Response to Public Exhibition of the State Significant Infrastructure Application for the Sydney Metro City & Southwest - Chatswood to Sydenham Greenwood Plaza and 101-103 Miller Street, North Sydney

This submission has been prepared on behalf of Mirvac Real Estate Pty Ltd, the manager of Greenwood Plaza and 101-103 Miller Street, North Sydney. The following sections of our correspondence provide:

FIGURE 5 – VICTORIA CROSS STATION TRANSPORT INTEGRATION (SOURCE: TRANSPORT FOR NSW, 2016)

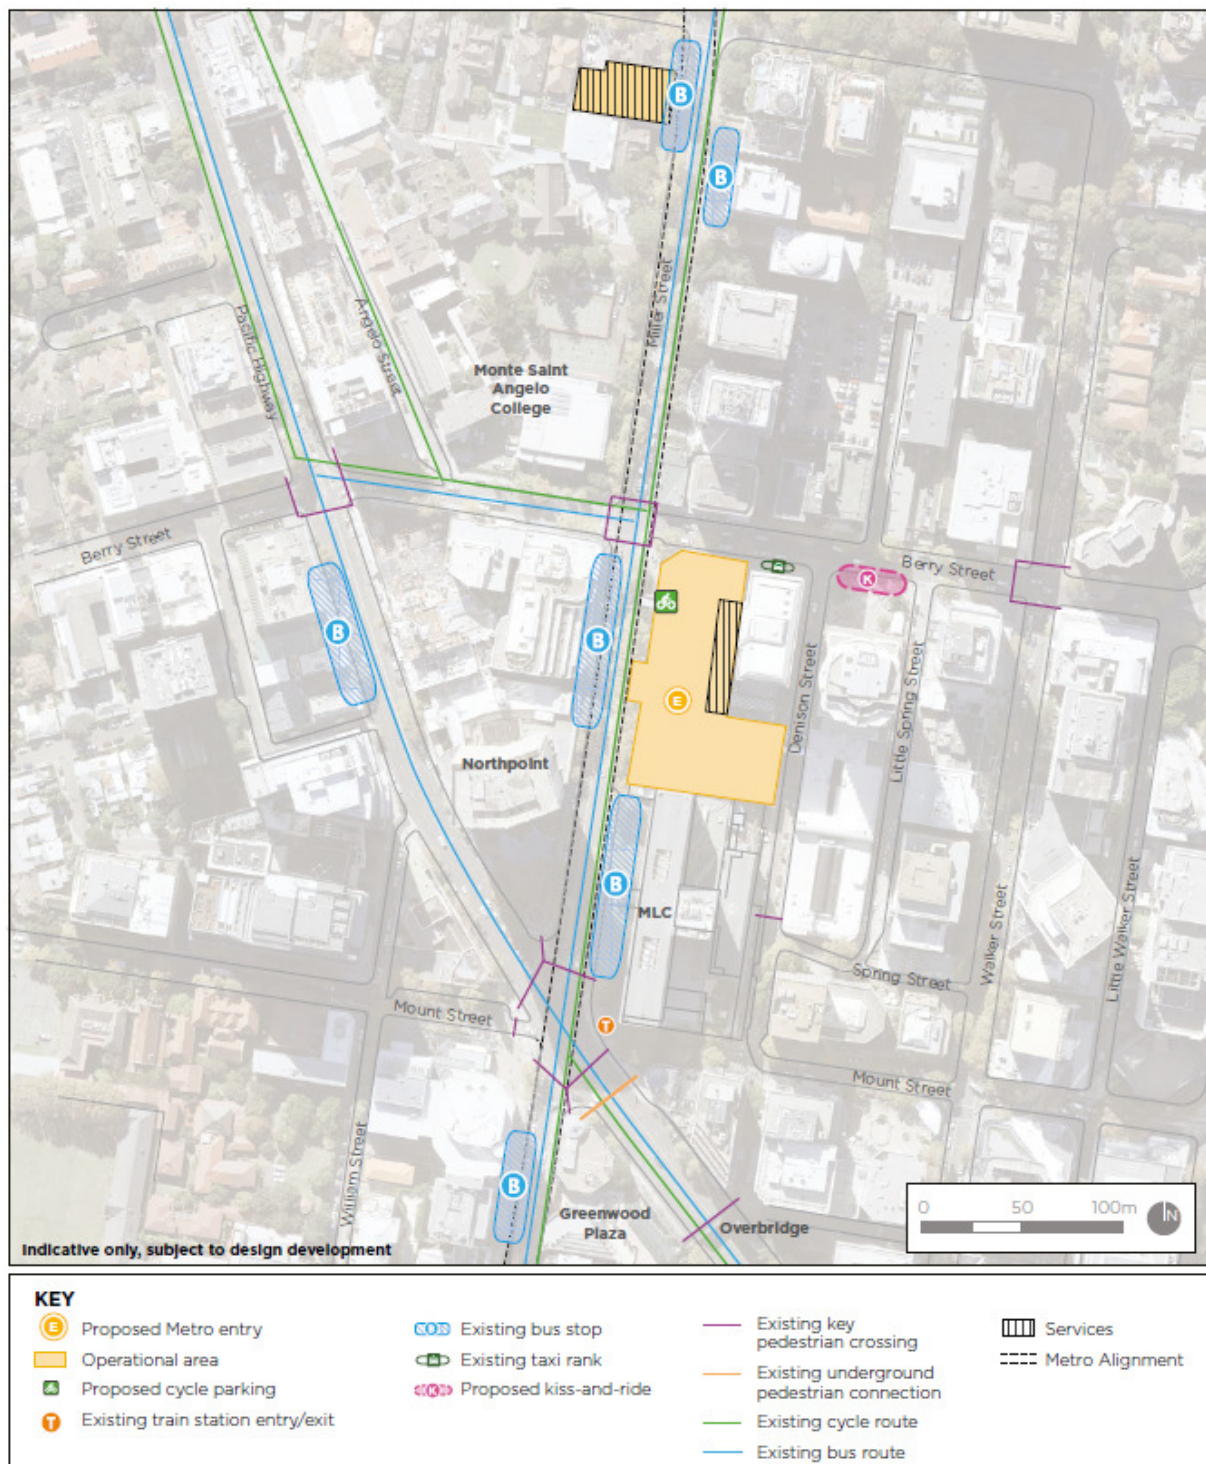
The EIS states that the pedestrian movement and access to the site has been considered as a priority as part of the station design. However, it does not appear that any detailed consideration has been given to the extension of the existing underground pedestrian links to provide for a more efficient and weather-protected link to North Sydney railway station via Greenwood Plaza. This is considered to be particularly relevant considering the high proportion of pedestrian movements that are expected to be towards the south of the proposed station.

The pedestrian modelling of the station and streetscape indicates that the majority of the footpaths in the locality would operate at Level of Service B or better. However, the intersection of Miller and Berry Streets and Denison Street could pose safety risks or impacts for pedestrians and/or traffic. It is unclear as to whether this assessment has given detailed consideration to the potential impacts of the bus interchange on Miller Street, particularly during the morning and evening peaks. Further, the EIS does not provide any contingency measures in the event that Denison Street cannot be fully pedestrianised due to the existing loading arrangements.

The EIS also states that the existing pedestrian islands between the Pacific Highway and Miller Street to the north and south of the intersection are already experiencing high levels of pedestrian use. However, no assessment has been provided with regard to the capacity of the pedestrian intersections to accommodate the anticipated increased demand. The EIS simply states that this matter would be

Overall, it is considered that the potential extension of the existing underground link from Greenwood Plaza to Victoria Cross Station should be further investigated. The provision of an underground pedestrian link could provide for more efficient and safer pedestrian movements, having particular regard to the existing capacity issues at the intersection of the Pacific Highway and Miller Street. It could also potentially relieve the pressure on the south-bound movements along Denison Street which are expected to operate at Level of Service E. It would appear that there is no existing certainty that the road can be pedestrianised to mitigate the potential safety issues and as such, it is considered appropriate to consider alternative options, such as an underground connection.
